IfSAR Quality Assurance (QA) Report

QA Report for Intermap Cells 333, 334, 335,
347, 348, 349, 361, 362, and 375

Produced for U.S. Geologic Survey

Report Date: April 29, 2020

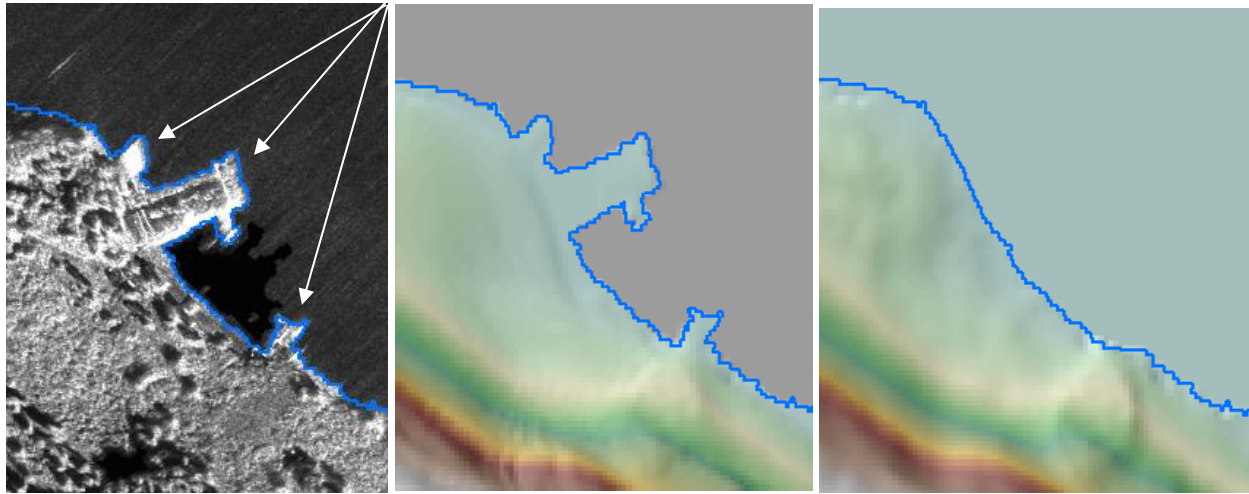
Thirteen locations were identified in the first delivery for piers flattened in the DSMs, or piers excluded in the hydro mask and not properly flattened in the DTMs. The piers were correctly included in the hydro mask (flattened in the DTMs) and modeled properly in the DSMs by Intermap in the second delivery. All DTMs and DSMs for Kodiak and St. Lawrence Lot 6 Option 1 conform to project specifications.

Piers, docks, and bridges should be fully modeled in the DSMs, but hydro-flattened in the DTMs. The hydro mask should match the DTMs to represent all areas hydro-flattened in the DTMs. In the first delivery, thirteen (13) areas were identified where docks or piers were either not modeled properly in the DSMs or were excluded in the hydro mask, causing the feature to not be flattened or modeled properly in the corresponding DTM and DSM. All piers/docks were addressed by Intermap in the second delivery and are modeled properly in the DTMs and DSMs. Examples are shown below.

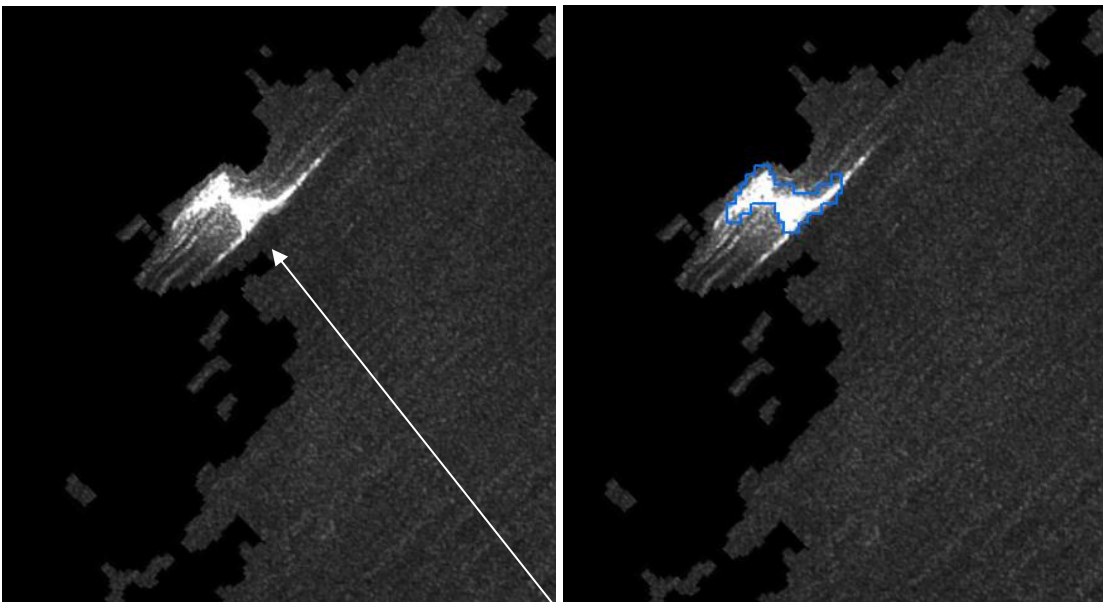
Eleven (11) areas were identified in the first delivery that required further investigation by Intermap to determine if valid land features were included in the hydro mask and flattened in the DTMs/DSMs. Intermap addressed the issues in the second delivery. An example is shown below.

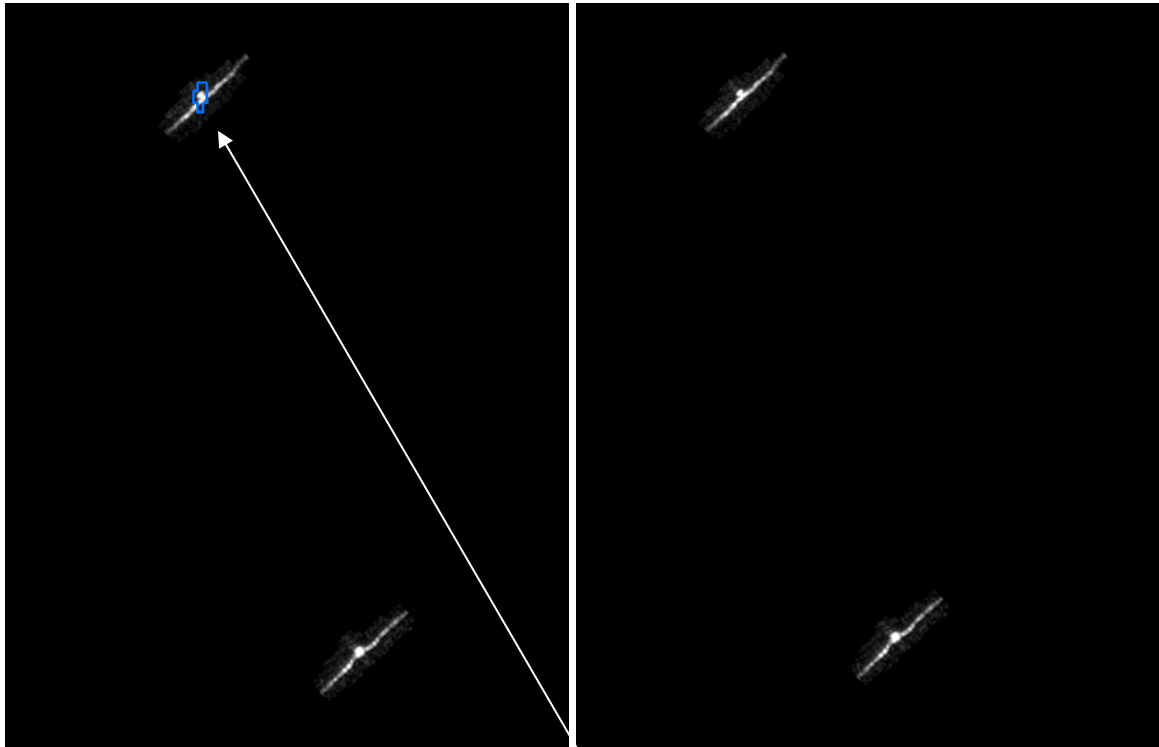
Twenty six (26) issues were identified in the first delivery where small islands collected in the hydro mask required further verification. These features show no valid land in the corresponding ORIs. Intermap reviewed the features and found no valid land. The hydro mask, DTMs, and DSMs were adjusted in the second delivery to address the small polygons. An example is shown below.
